HISTORIC AND DESIGN REVIEW COMMISSION

August 21, 2019

HDRC CASE NO: 2019-450
ADDRESS: 110 LEXINGTON
LEGAL DESCRIPTION: NCB: 804 BLK: 32 LOT: W IRR 69.22' OF A9 & W IRR 96.14' OF A10
ZONING: FBZ T6-2, H, RIO
CITY COUNCIL DIST.: 1
APPLICANT: Ian McClure/Phoenix Hospitality Group
OWNER: Edward McClure/EL TROPICANO HOTEL LLC
TYPE OF WORK: Exterior modifications, rehabilitation, partial demolition, and demolition of the existing parking garage
APPLICATION RECEIVED: August 02, 2019
60-DAY REVIEW: October 01, 2109
CASE MANAGER: Edward Hall
REQUEST:

The applicant is requesting a Certificate of Appropriateness for approval to:

PROPOSED SCOPE - EAST ELEVATION

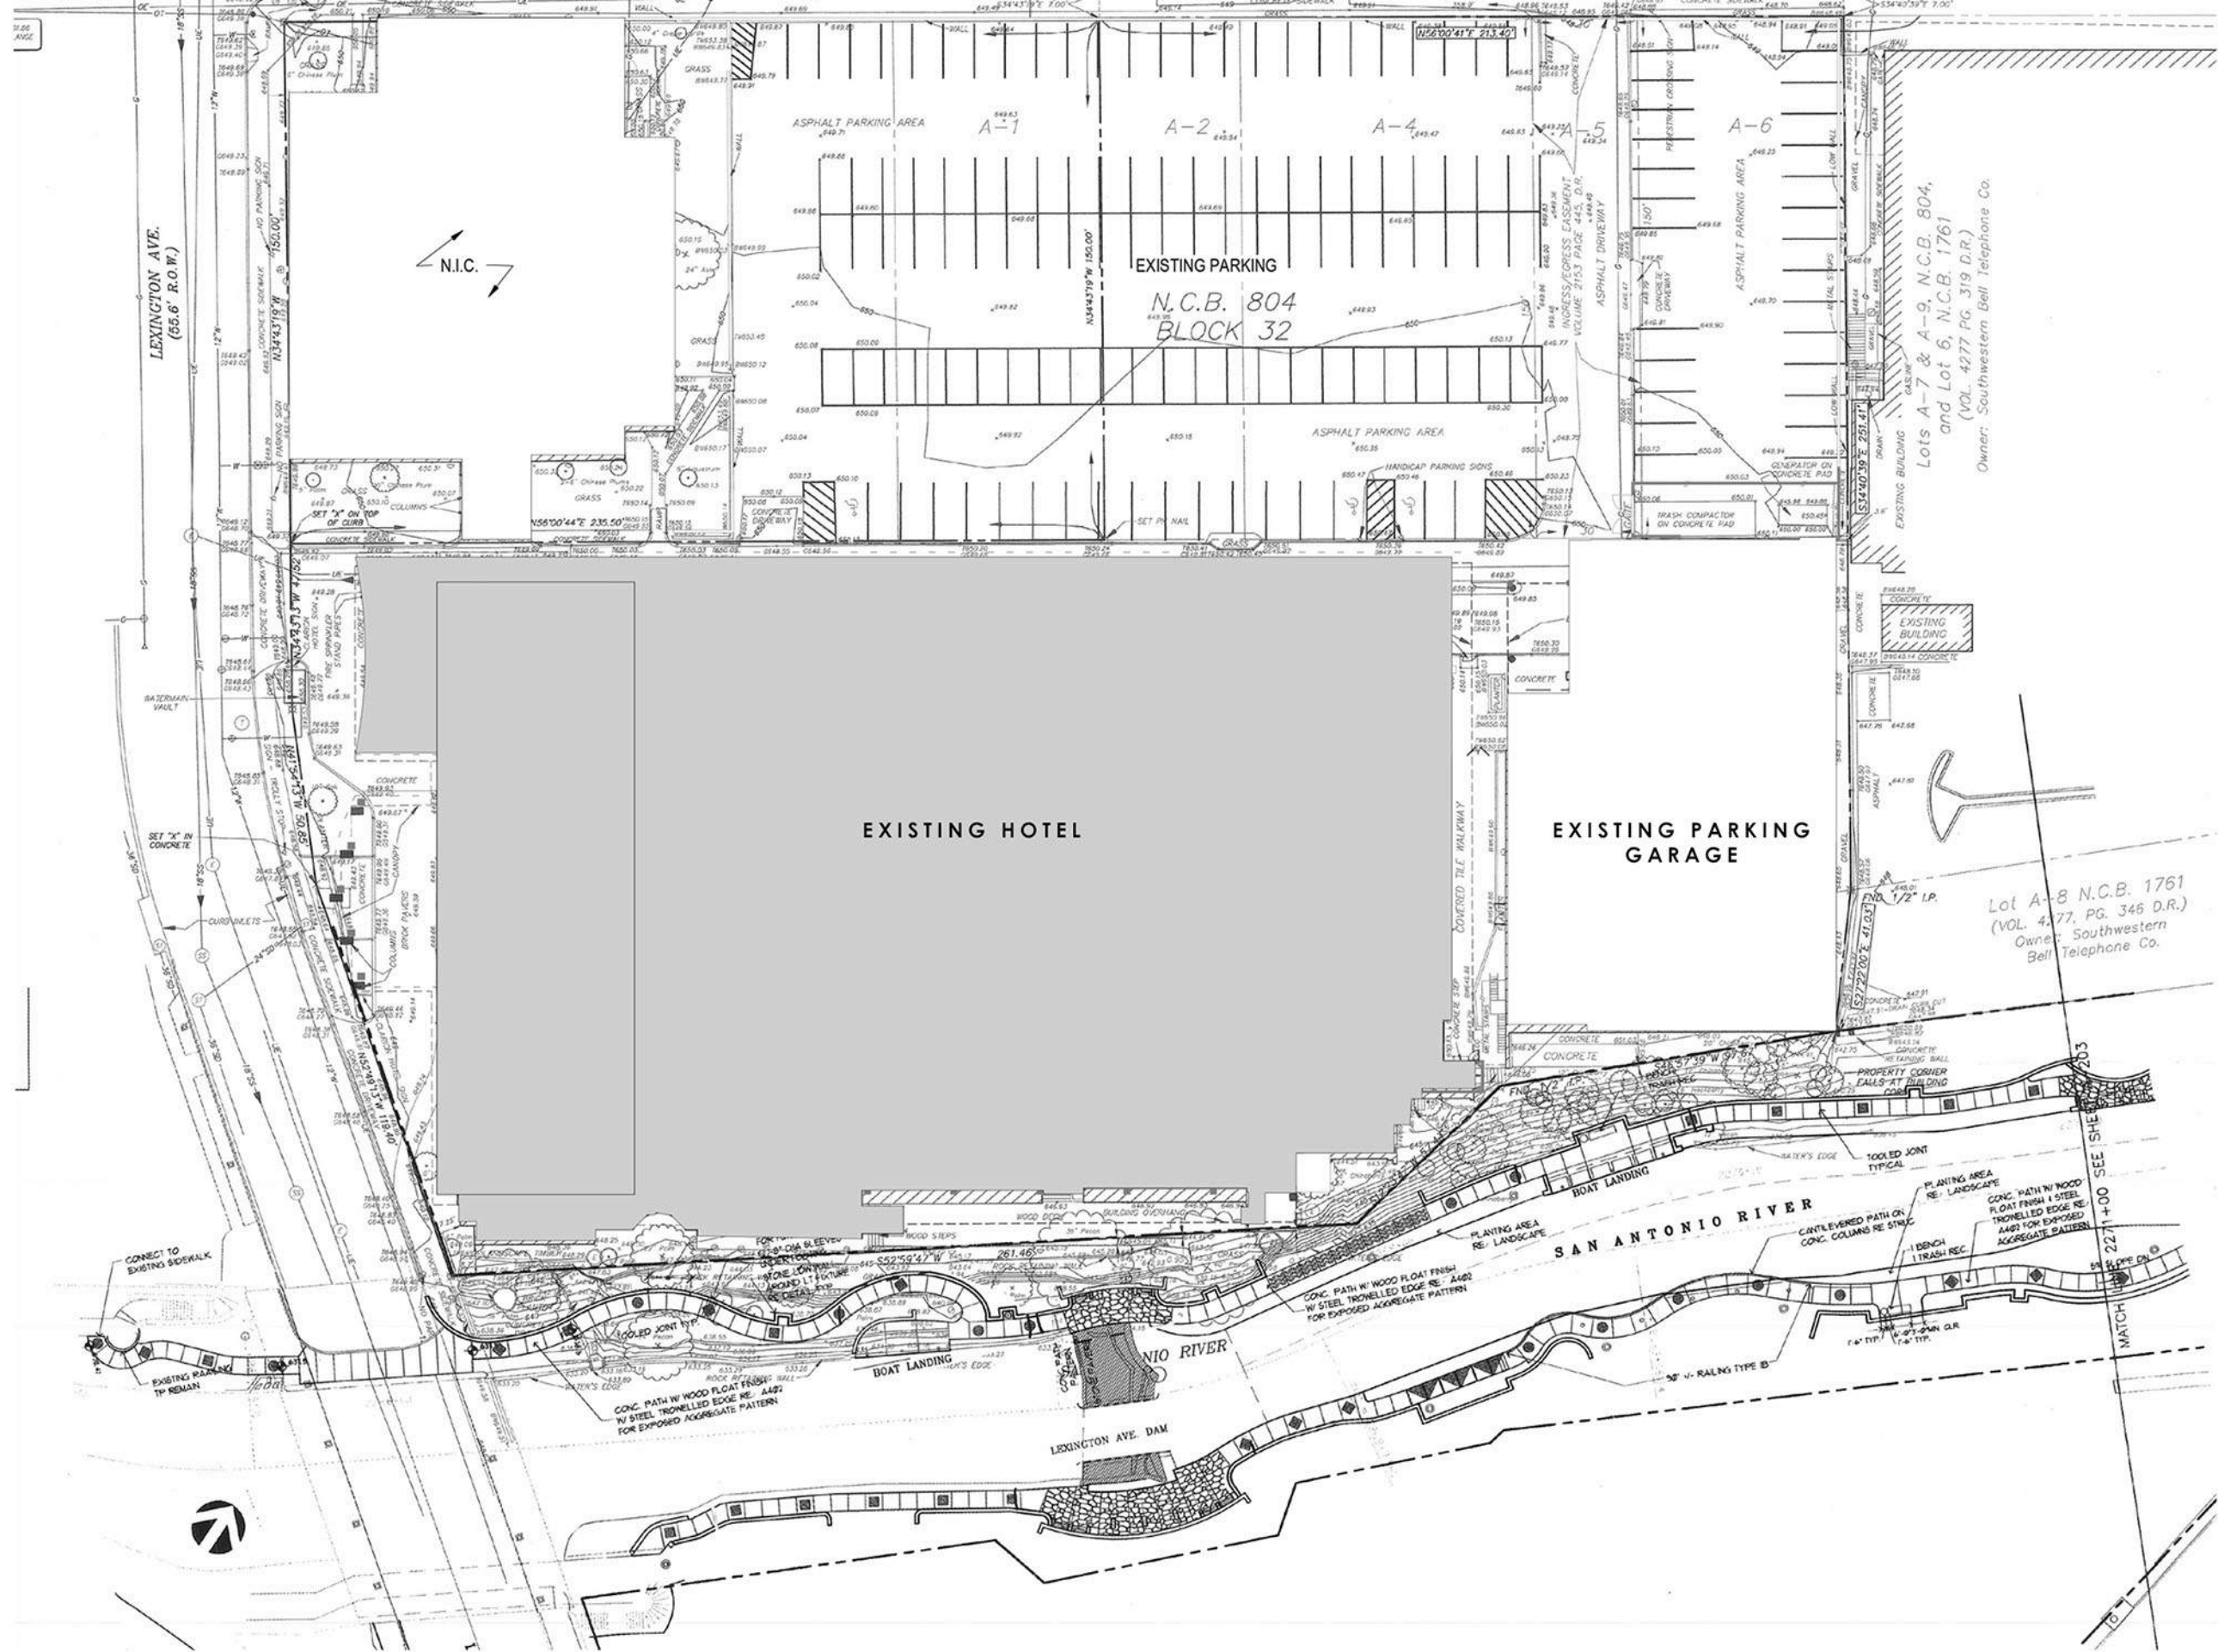
- p. EASTERN WING DEMOLITION – The applicant has noted the demolition of the eastern portion of the historic structure, which is original, to provide additional space for future new construction. The northeast portion of the hotel proposed for demolition is original to the site and contributes to the local historic landmark. At this time, staff finds that the applicant has provided insufficient information regarding this demolition and the treatment and east elevation of the historic structure after this demolition. Staff does not find the partial demolition of a historic structure to be appropriate.
